**Chemung County Stormwater  
Construction Inspection  
Erosion and Sediment Control**

<b>Project Name</b> Six67 Apartments	<b>Date</b> 8/13/2021
<b>Location</b> W. Fifth and College Ave. City of Elmira	<b>Permit #</b> NYR11G564
<b>Weather Conditions</b> sunny, warm	<b>Entry Time:</b> 8:55 am
<b>On-Site Representative Present:</b> none	<b>Exit Time:</b> 9:27 am

**PROJECT:** Six67 Apartments  
City of Elmira  
Municipal Construction Inspection  
August 13, 2021

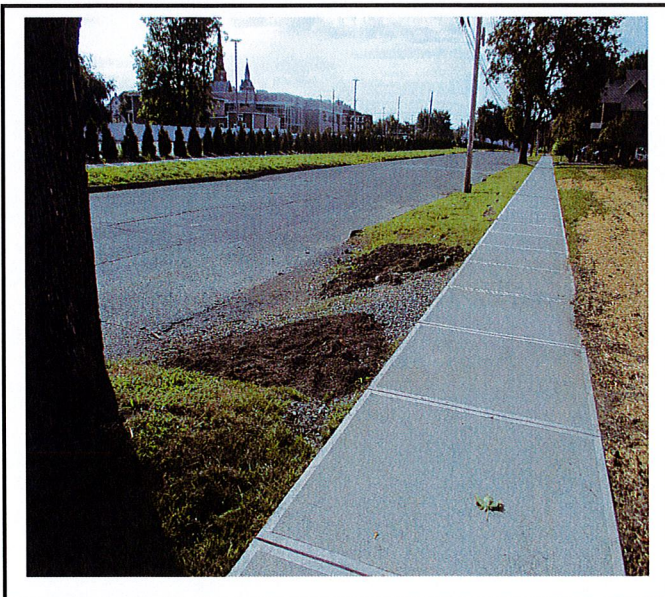
Area along Columbia Street requires stabilization.

Area along Fifth Street that has been re-stabilized.

Area along College Ave needing stabilization.

Drainage Grates between the building and the sidewalk need to have the fabric removed from under the grate.
